DOCUMENT - 2023-518T
Gender Neutral Changeroom Upgrades at Tomken and Rising Hill
Reporting Stations for Peel Regional Paramedic Services, City of
Mississauga and Brampton, Project 23602

ADDENDUM 2

DRAWING TITLE
**WASHROOM & SHOWER RCP, DOOR
SCHEDULE AND ROOM FINISH SCHEDULE**

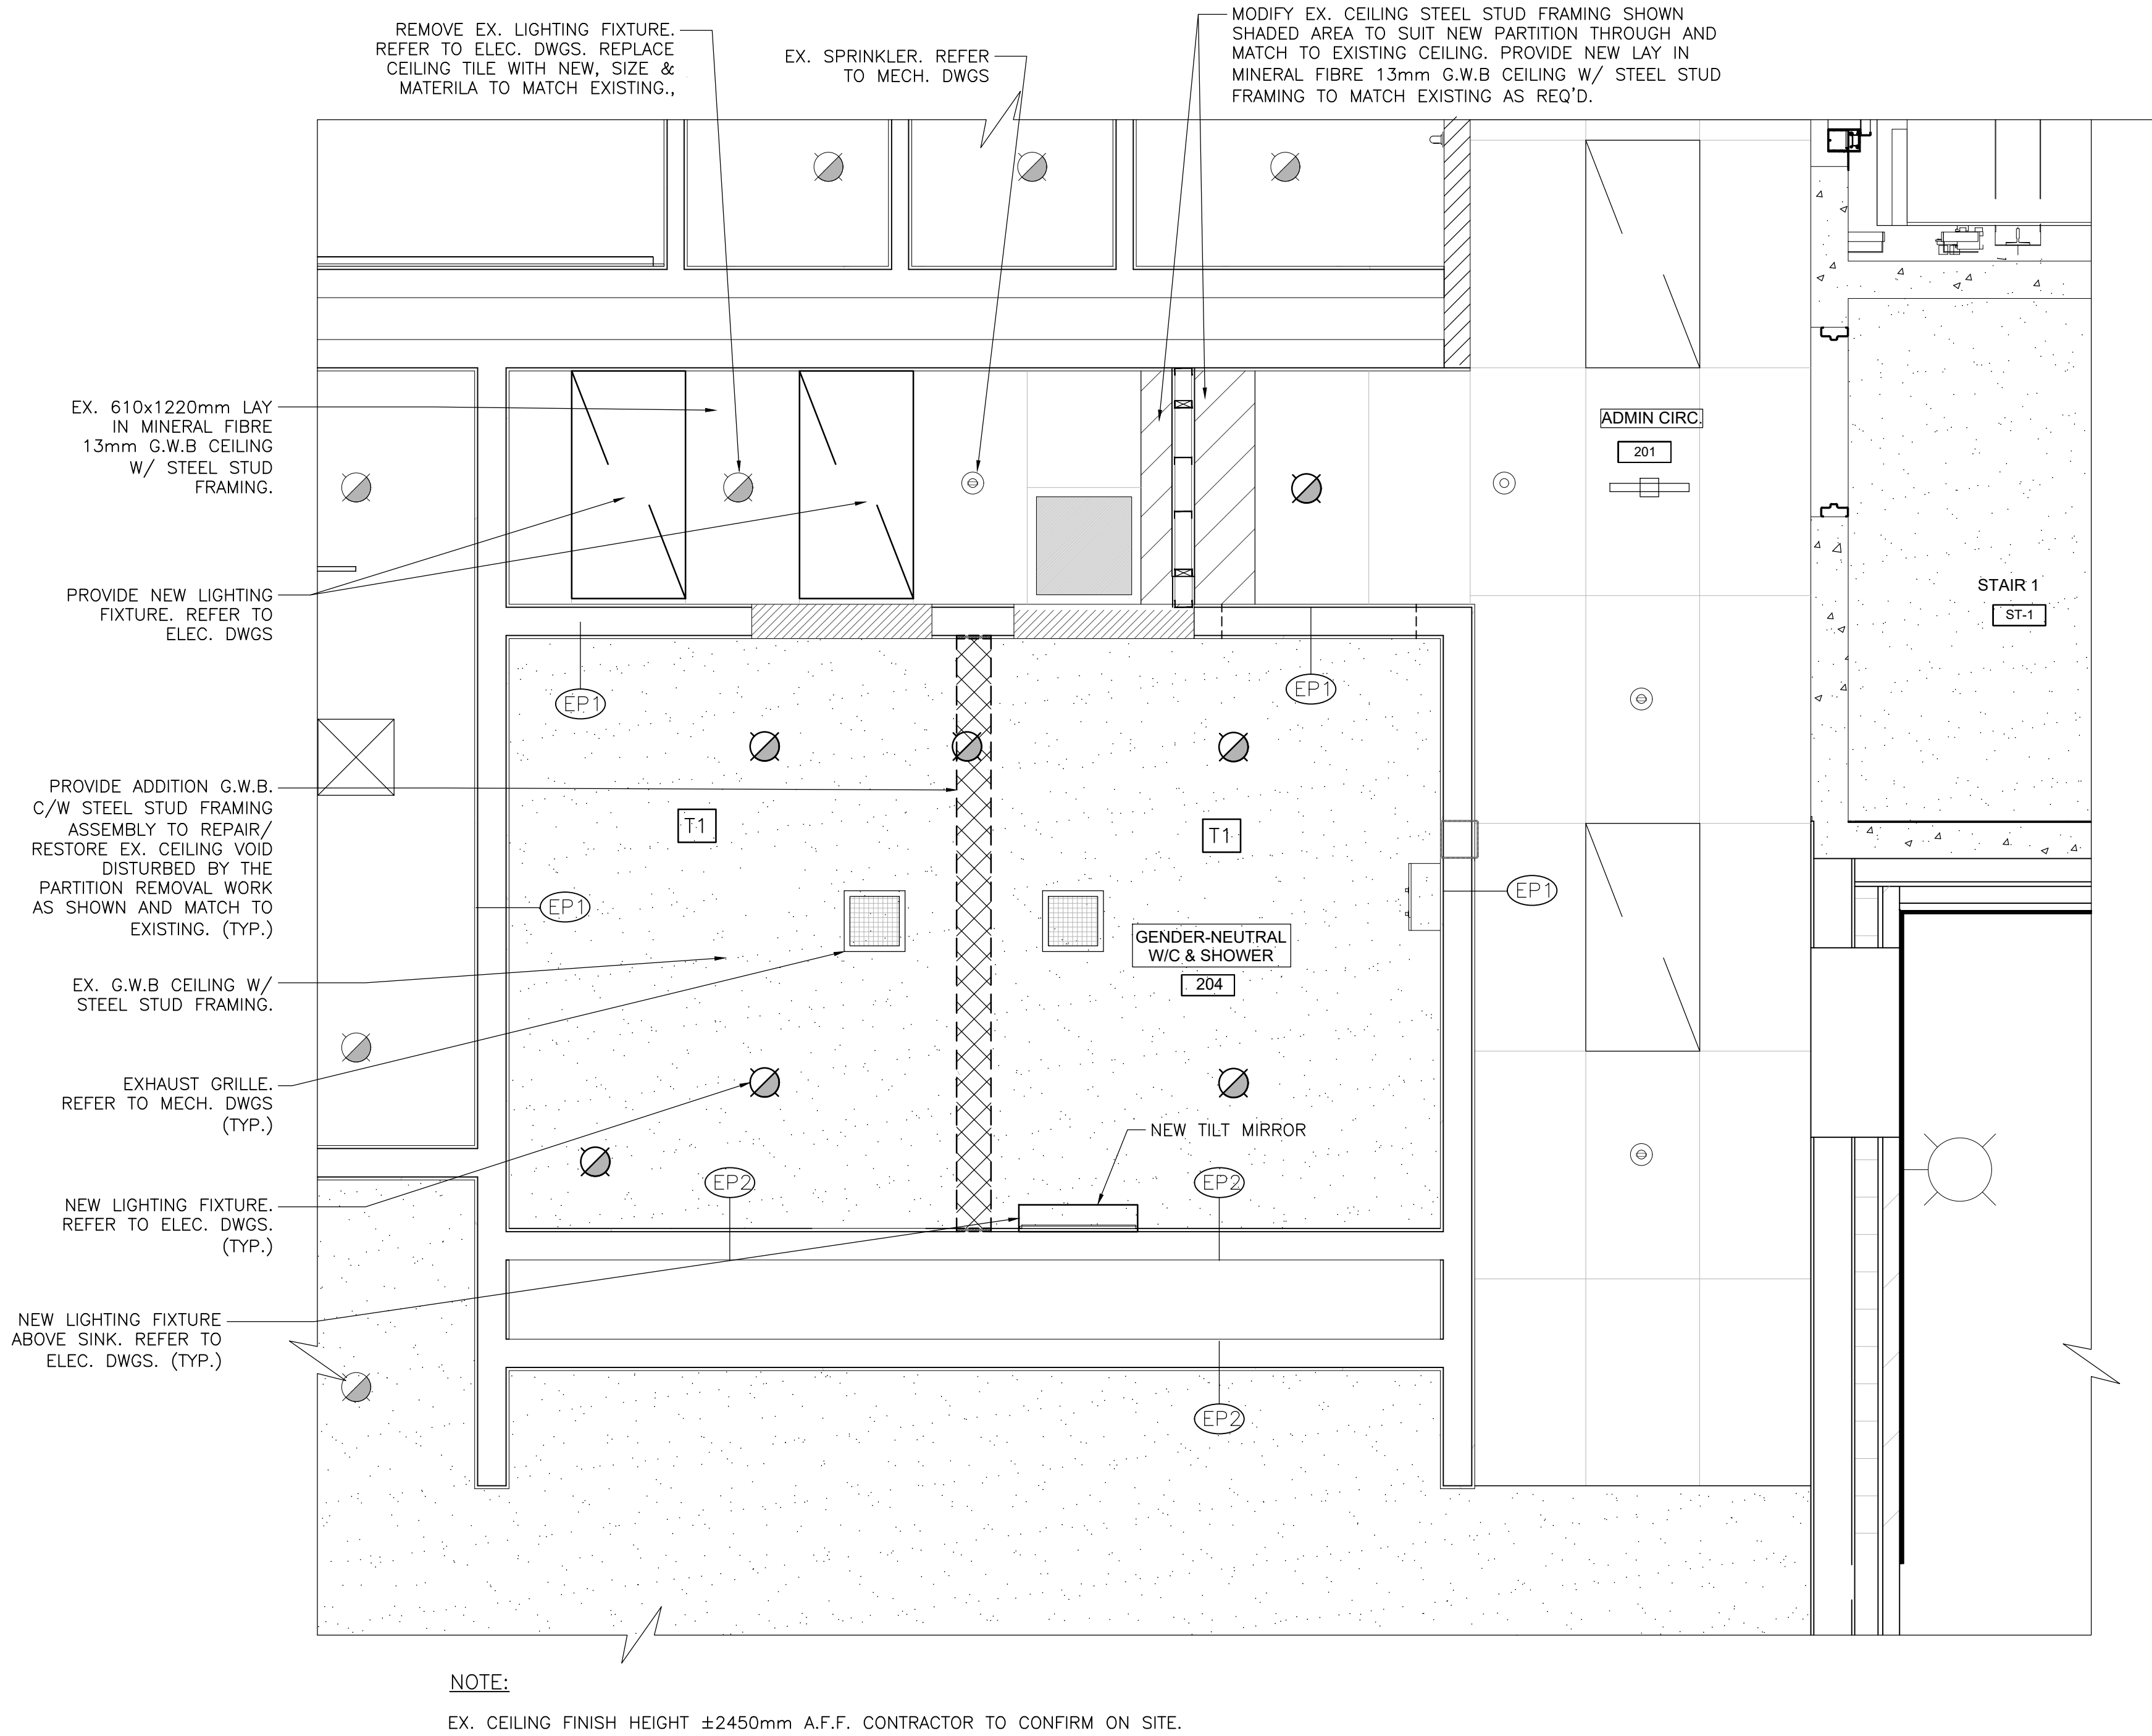
There is discrepancy between room finish schedule and drawing A03,detail 1 (Rising Hall Brampton), Storage rm 205 drawing shows existing floor finish to remain, however, on finish schedule it states new epoxy floor with 8" cove base? Please clarify.

On the Rising Hill location, the material schedule under Storage Room 205 notes F1 Tile Flooring to Match F1 Tile Flooring. Although, F1 is noted as epoxy. Please clarify.

Provide new epoxy flooring and cove in Storage Room 205.

Change New Tile Flooring in Storage Room 205 to New Epoxy Flooring and match to F1.
